GOVERNMENT OF THE DISTRICT OF COLUMBIA
DEPARTMENT OF TRANSPORTATION

MEMORANDUM

SUBJECT: BZA Case No. 19165 – 1301 H Street NE

Figure 1. Proposed Site Plan (Source: Applicant)

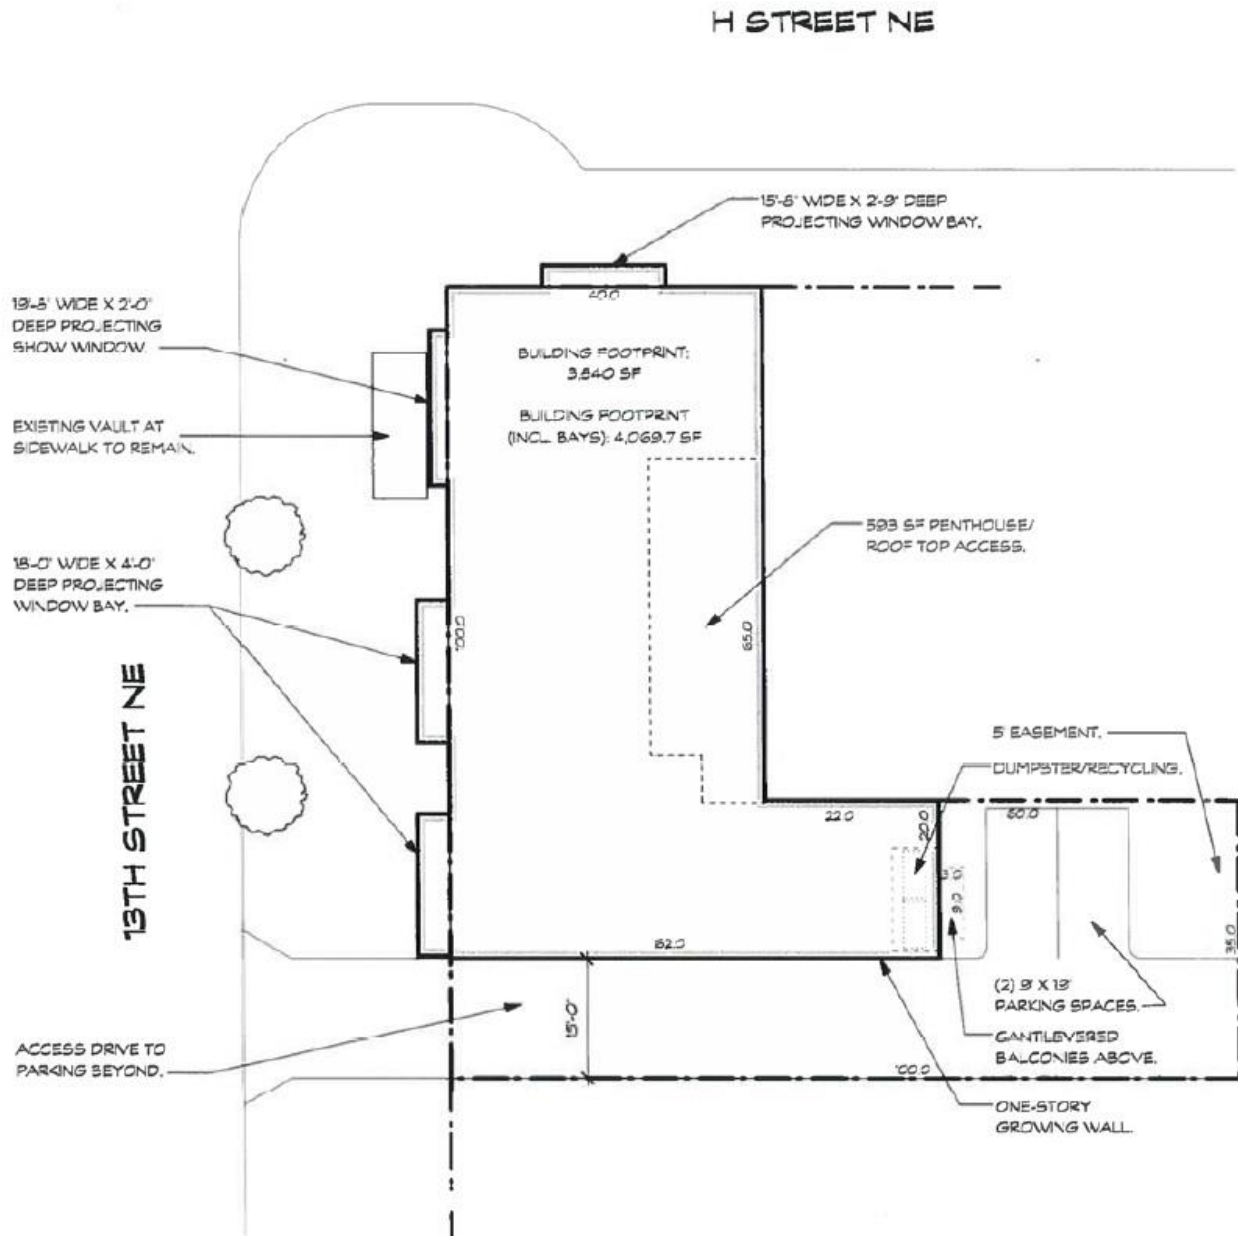
Zoning regulations require a 30' loading berth and a 100 sf loading platform. The project seeks a variance from this requirement, providing no onsite loading. The Applicant proposes to utilize on-street loading from the bus loading and unloading zone (for the Rock and Roll Hotel) located adjacent to the Site. Trash collection is also proposed to occur via this same location. Per the Applicant, the hotel has been coordinated with and is amenable to this shared use. DDOT will work with the Applicant and hotel to determine this shared usage.

A workable loading concept is necessary to show this building can function effectively. While the relatively modest use by motorcoaches of the bus loading and unloading zone may allow complementary loading activity, DDOT is concerned about the function of this space should dueling needs arise. As such, DDOT seeks to see the Applicant work with DDOT to most appropriately update the signage for this space. As well, further documentation as to the hotel's willingness to share this space should be provided in writing. With this space available, DDOT does find that the most common service/delivery/moving/trash trucks anticipated could be accommodated. DDOT expects the Applicant to address these details further as part of the permitting process for this property.

- Installation of at least three short-term bicycle parking spaces in public space; and
- Provision of at least five years of Capital Bikeshare and carsharing memberships to each unit in the building.
